**ADDENDUM NO. 2**

PROJECT TITLE:  
**REPLACEMENT OF  
 BRIDGE NO. 06896, ROUTE 156  
 OVER ARMSTRONG BROOK**

TOWN:  
**OLD LYME**  
 DRAWING TITLE:  
**RIGHT-OF-WAY  
 PLAN**

PROJECT NO.  
**104-175**  
 DRAWING NO.  
**ROW-1**  
 SHEET NO.  
**03.02.A2**

- SEE MPT DRAWINGS FOR TRAFFIC CONTROL LAYOUT.

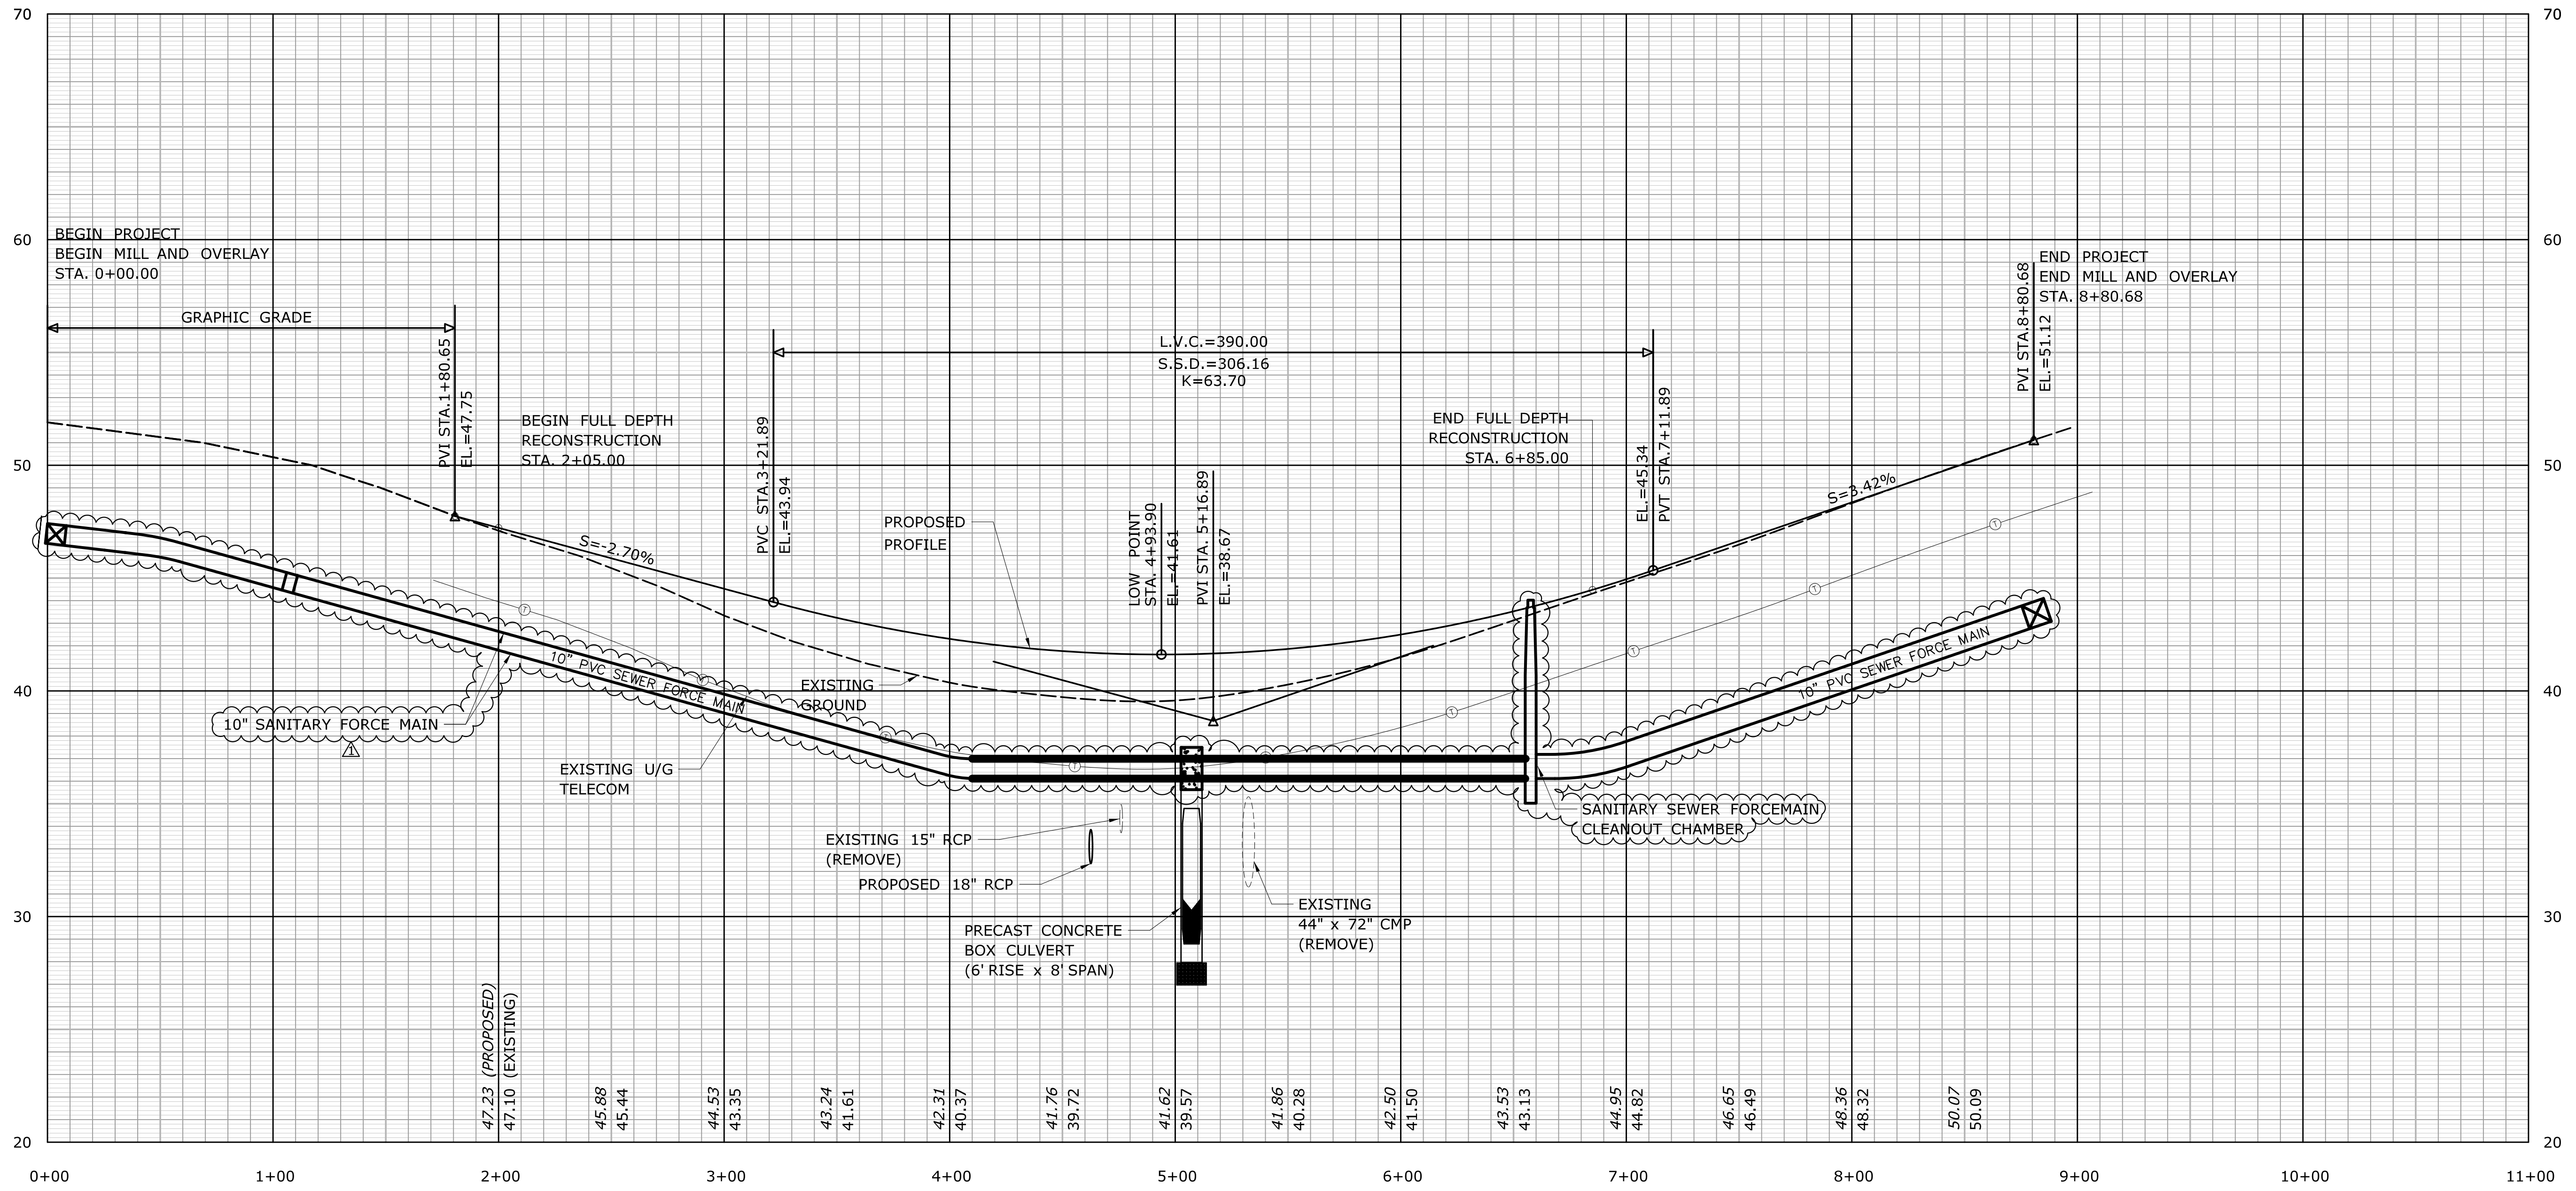
ADDENDUM NO. 2 01.31.25 REV. DATE	ADD SANITARY FORCE MAIN REVISION DESCRIPTION	03.03 SHEET NO.	THE INFORMATION, INCLUDING ESTIMATED QUANTITIES OF WORK, SHOWN ON THESE SHEETS IS BASED ON LIMITED INVESTIGATIONS BY THE STATE AND IS IN NO WAY WARRANTED TO INDICATE THE CONDITIONS OF ACTUAL QUANTITIES OF WORK WHICH WILL BE REQUIRED. Plotted Date: 2/6/2025	DESIGNER/DRAFTER: <b>M. STOYF/ N. ROSSI</b> CHECKED BY: <b>S. ROSE</b> SCALE IN FEET 0 40 80 SCALE 1"=40' Filename: ...VHW_MSH_0104_0175_(03)_Br06896_PLAN.dgn	 <b>STATE OF CONNECTICUT</b> <b>DEPARTMENT OF TRANSPORTATION</b> 	SIGNATURE/ BLOCK:  PROJECT TITLE: <b>REPLACEMENT OF          BRIDGE NO. 06896, ROUTE 156          OVER ARMSTRONG BROOK</b>	TOWN: <b>OLD LYME</b> DRAWING TITLE: <b>ROADWAY          PLAN</b>	PROJECT NO. <b>104-175</b> DRAWING NO. <b>PLN-01</b> SHEET NO. <b>03.03.A2</b>
---	---	--------------------	---	---	--	--	--	---

SHEET NO.  
**03.06.A2**

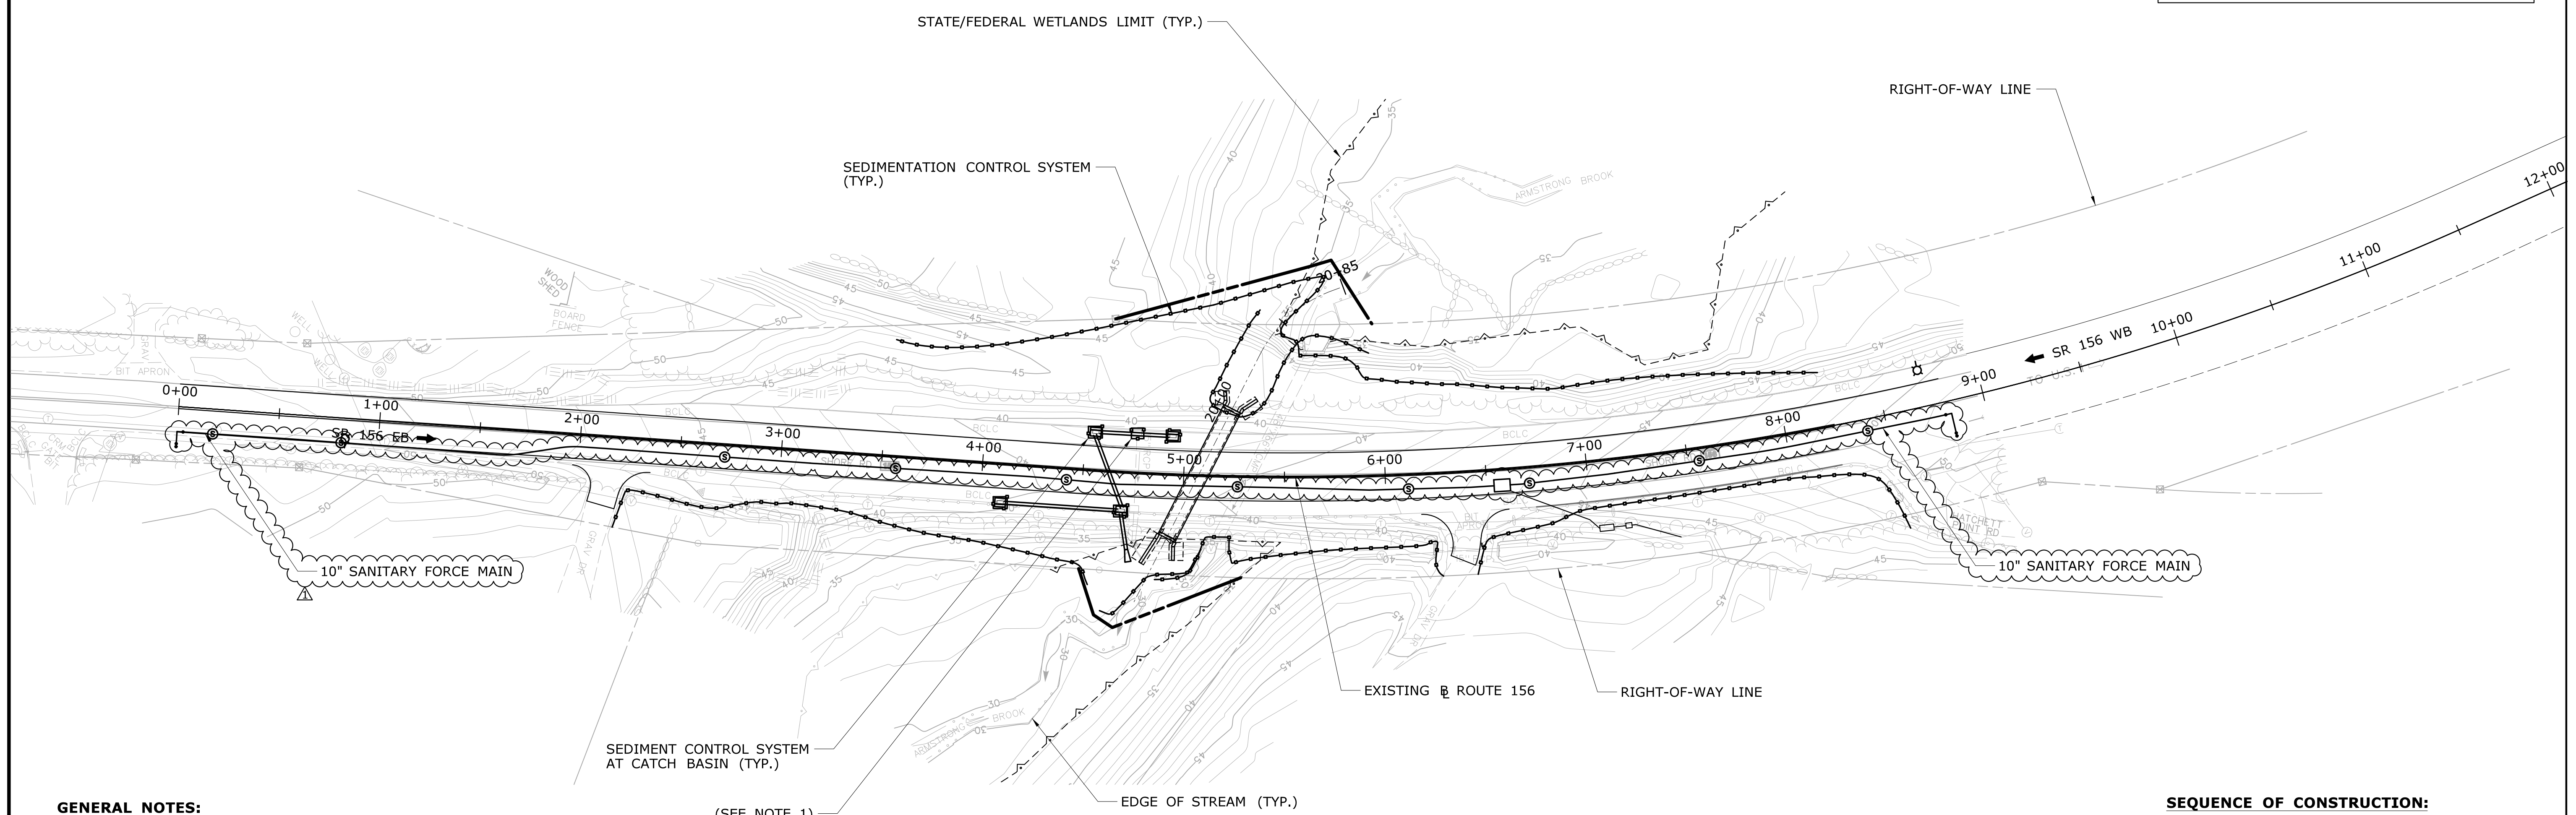
REV.	DATE	REVISION DESCRIPTION	SHEET NO.
1	1.31.25	ADD SANITARY FORCE MAIN	03.06

SHEET NO.  
**03.11.A2**

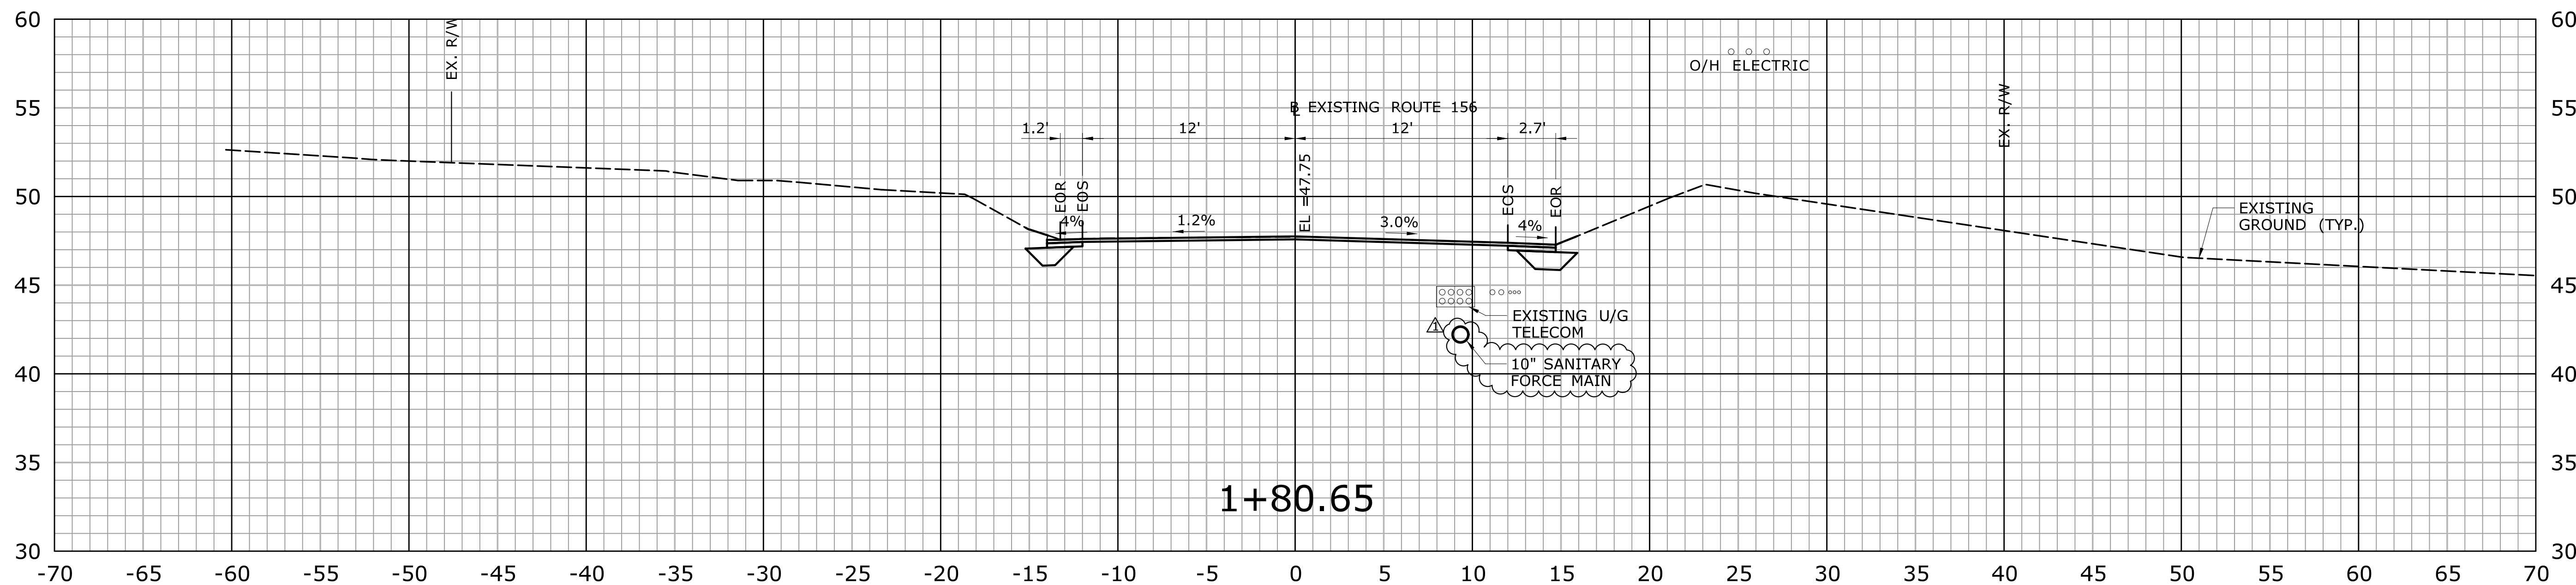
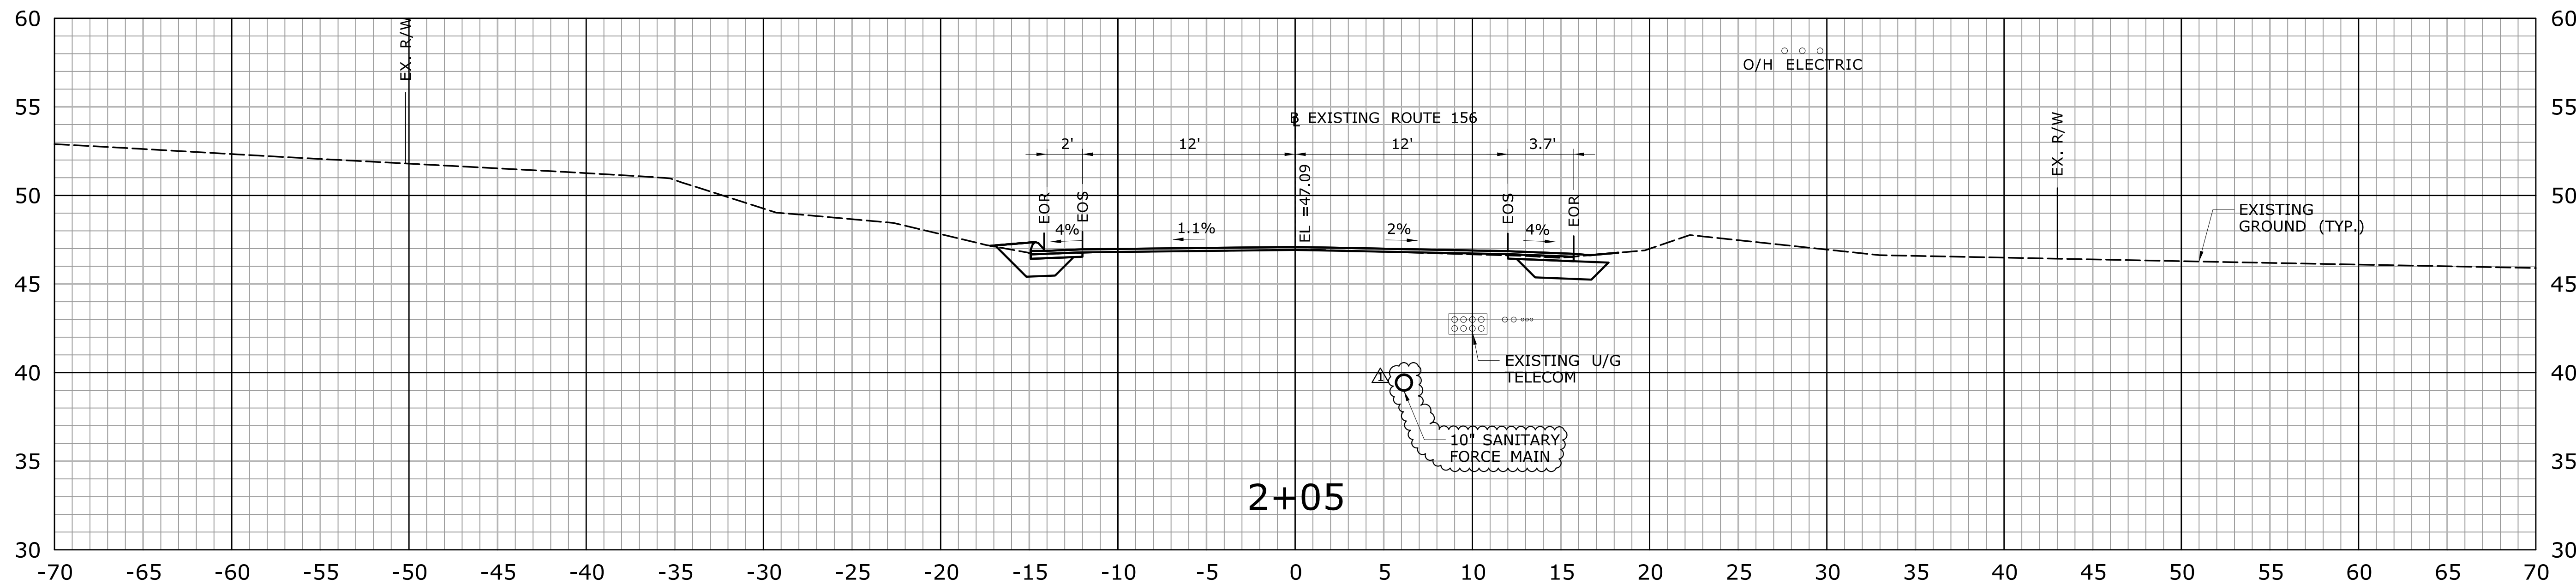
REV.	DATE	REVISION DESCRIPTION	SHEET NO.
1	1.31.25	ADD SANITARY FORCE MAIN	03.11

SHEET NO.  
**03.12.A2**

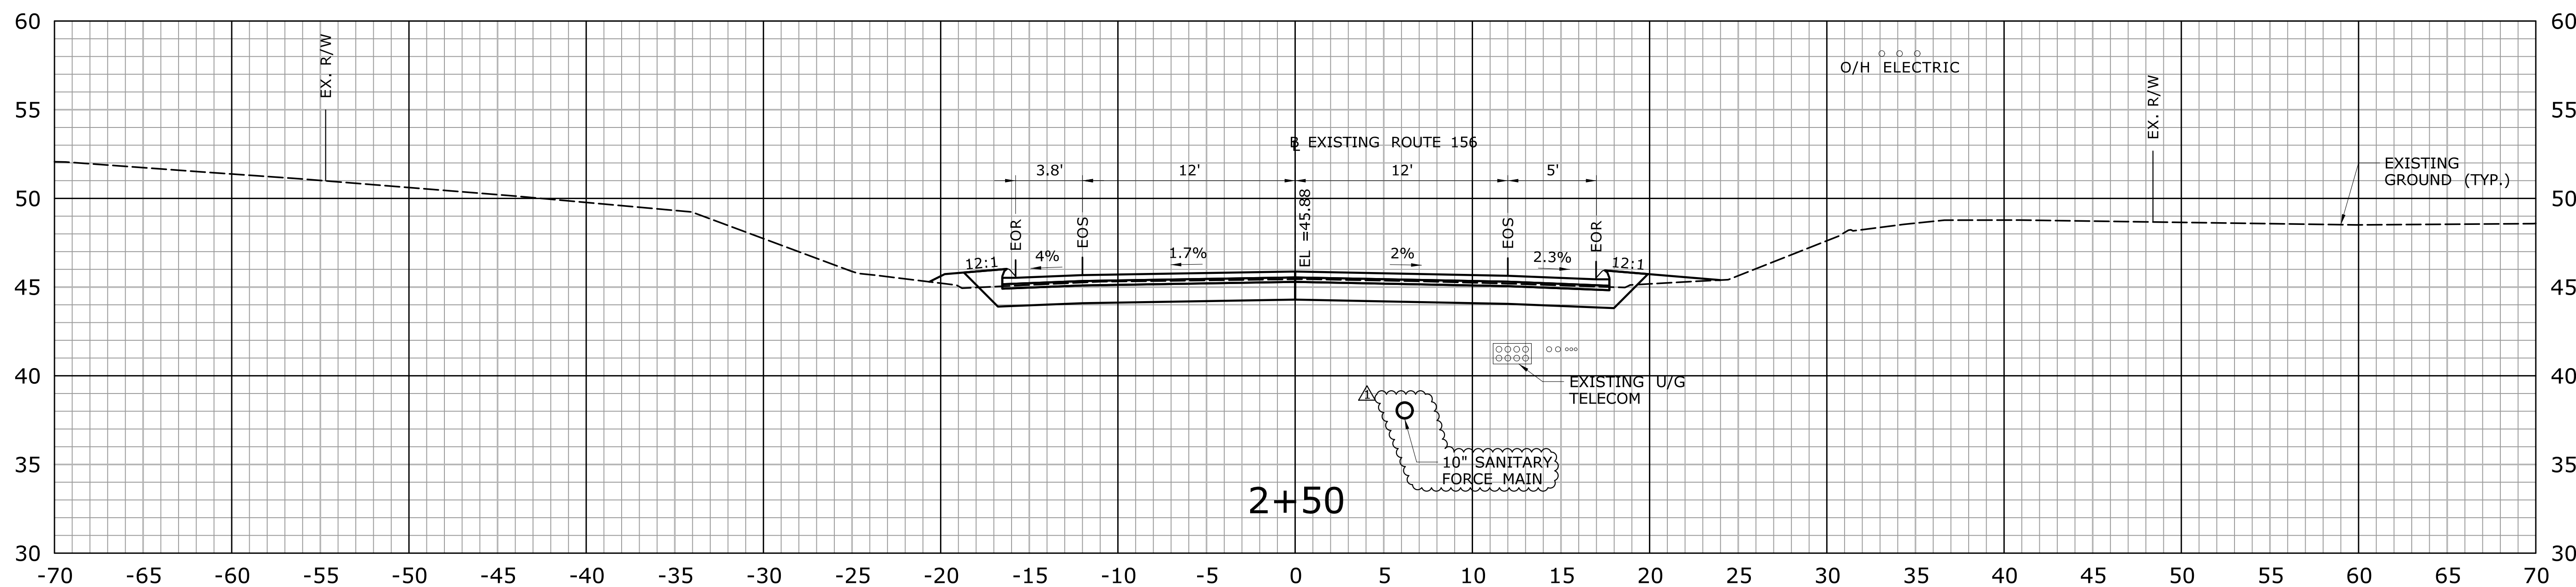
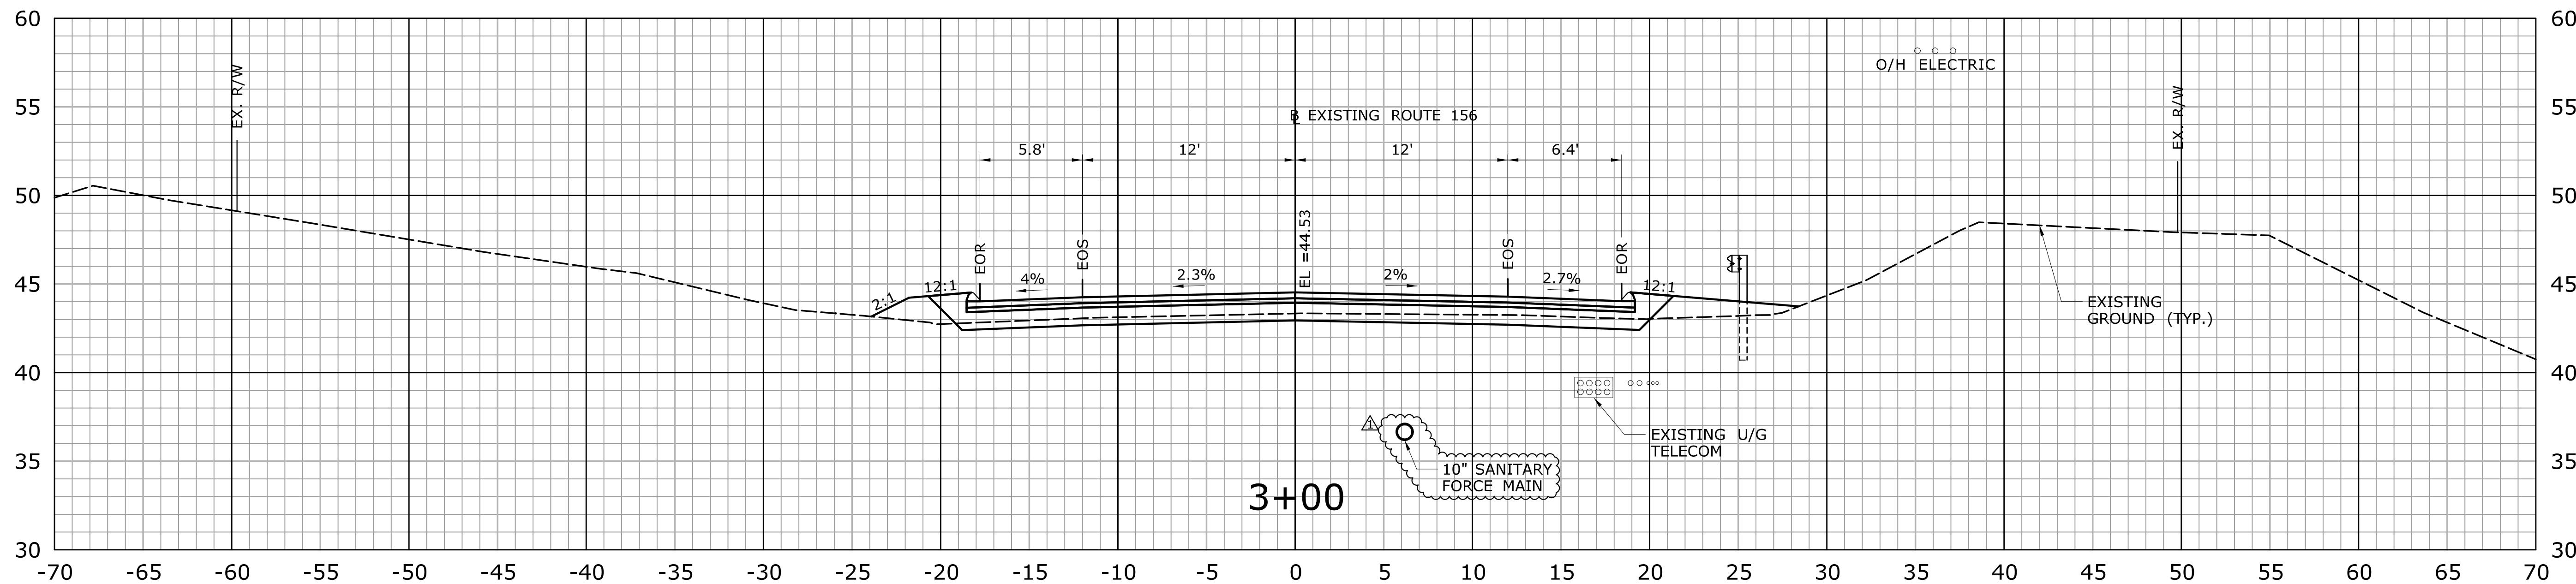
REV.	DATE	REVISION DESCRIPTION	SHEET NO.
1	1.31.25	ADD SANITARY FORCE MAIN	03.12
